INDESIT company

Model type:
WAT8IT

Commercial code:
F026453

n1040245: Brembate washing machine basket doors re

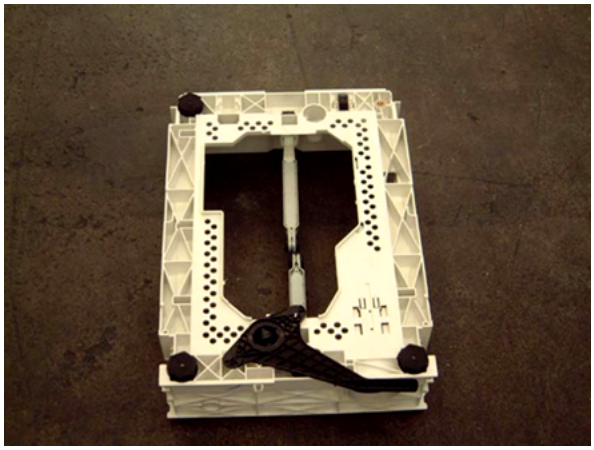
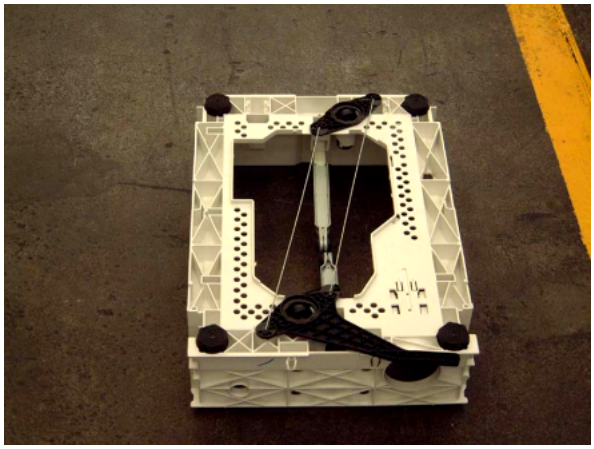
For all washing machine models produced in the Brembate factory and relevant to this note, in replacing the loading mouth code 083895/112743/252375 proceed as follows:
-remove the 18 rivets (9 on the right, 9 on the left) hooking the two doors to the loading mouth on the machine;
-take replacement part 083895/112743/252375 and carry out the same operation described in the previous point;
-hook the two new doors and the new loading mouth on the basket of the machine using the nut and bolts kit code 080691 (formed of 18 screws + 18 washers + 18 nuts);
-use silicone (SAT code 081629) for hooking the loading mouth on the basket.

FIG. 1

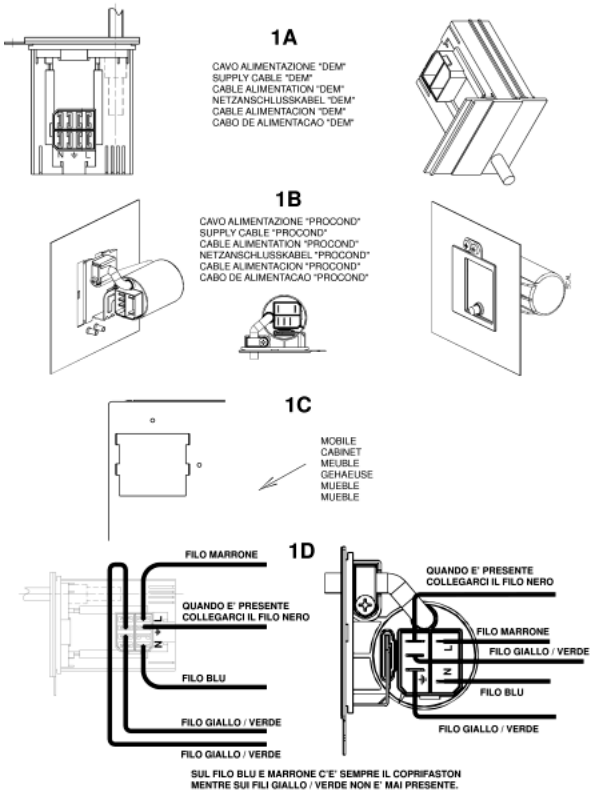
To use premodified wirings on modified products perform the connection to the terminal block of the new cable as shown in fig. 1 - 1D.
The wiring diagrams indicated in the Documentation remain the same.

N1040309FIG1

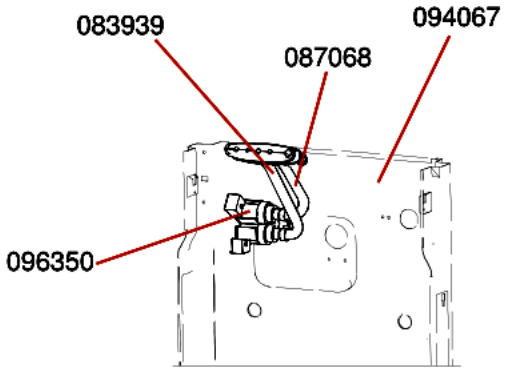
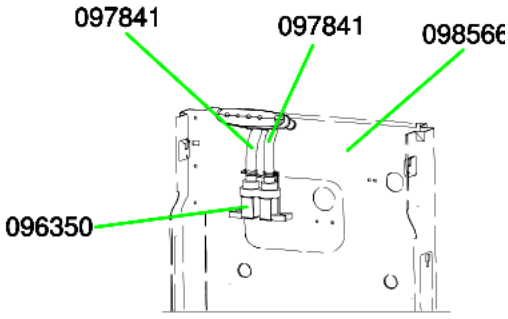
From serial no. 30912.0001, the system used for fixing the loading solenoid valve (spare part code 096350) to the rear panel has been modified on Top Loading washing machines, rotating its position by 90°.
The solenoid valve (spare part code 096350) has been modified with the 45° rotation of a coil; the Replacements Warehouse will continue to manage this part with the same code. When replacing on premodification machines, fit the coils as shown in figure N1040309FIG3-1 and on modified machines, as shown in figure N1040309FIG3-2; to rotate the coil, lift it using a screwdriver and then refit according to the inserts on the plastic.

FIG1 A - PREMODIFICATION STRUCTURE
solenoid valve tube/distributor assembly: premodification 083939;
solenoid valve tube/distributor assembly: premodification 087068;
rear panel: premodification 094067.
FIG1 B - NEW STRUCTURE

solenoid valve tube/distributor assembly: new 097841;
solenoid valve tube/distributor assembly: new 097841;
rear panel: new 098566.

N1040309FIG2

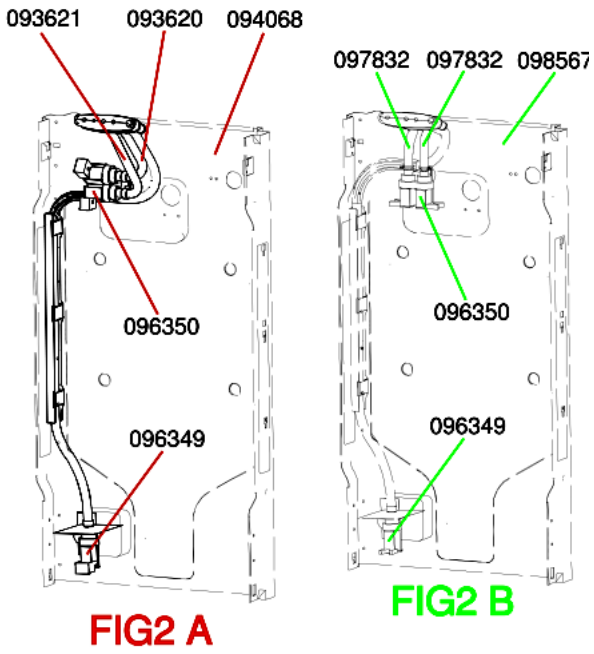
Replacement codes of the parts affected by the modification to WMTL80UK (see figure N1040309FIG2):

FIG2 A - PREMODIFICATION STRUCTURE
solenoid valve tube/distributor assembly: premodification 093620;
solenoid valve tube/distributor assembly: premodification 093621;
rear panel: premodification 094068.
FIG2 B - NEW STRUCTURE
solenoid valve tube/distributor assembly: new 097832;
solenoid valve tube/distributor assembly: new 097832;
rear panel: new 098567.

n1040321: Plastic protecion for solenoid valve.

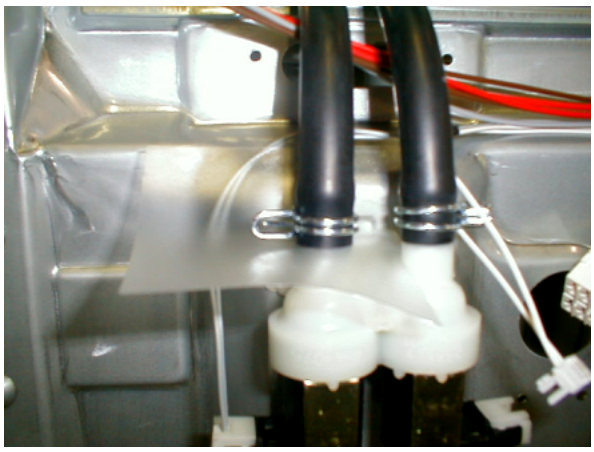
All top-load washing machines produced from September 2003 to February 2004 (from serial no. 30900.0000 to 40300.0000) have been equipped with a plastic protection Service code 109798 (shown in N1040321FIG1), to prevent water from damaging the solenoid valve and electronic card.

N1040324FIG1

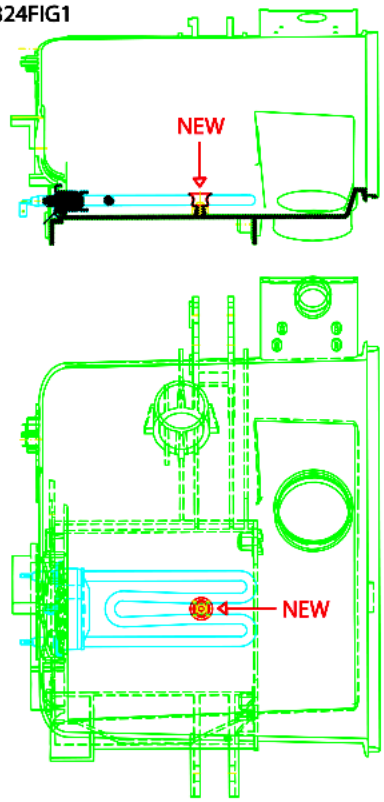
From serial number 40506.0001, the fixing system of the heater to the tank has been modified on all top-load washing machines affected by this note, with the introduction of a metal retainer (image N1040322FIG1 reference NEW) in place of deflector Service code 055322.

The modification has involved both heater and tanks. Given below are the Service codes of the new and old items concerned:

-PLASTIC TANK FOR 600-1000 RPM MACHINES: new 110152, premodification 083805;

-PLASTIC TANK FOR 1200 RPM MACHINES: new 110153, premodification 092023;

-HEATER: new 110148, premodification 083906.

N1040404FIG1

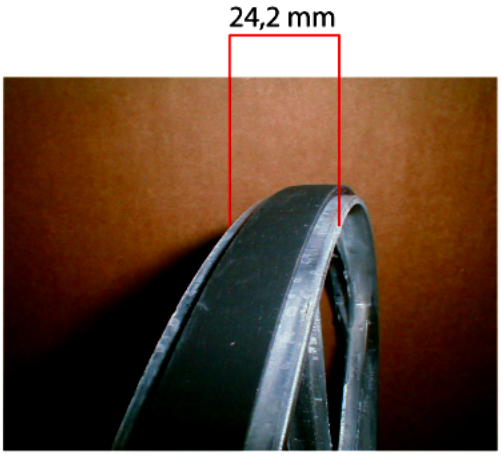
From serial no. 51202.0001 the pulley track has been widened from 21.2mm to 24.2mm (see picture N1040404FIG1).

new pulley
C00142832 - D280 24.2 mm track

Premodification pulley
C00083912 - D280 21.2 mm track

The new pulley can also be used on premodification versions of the models referred to in this release.
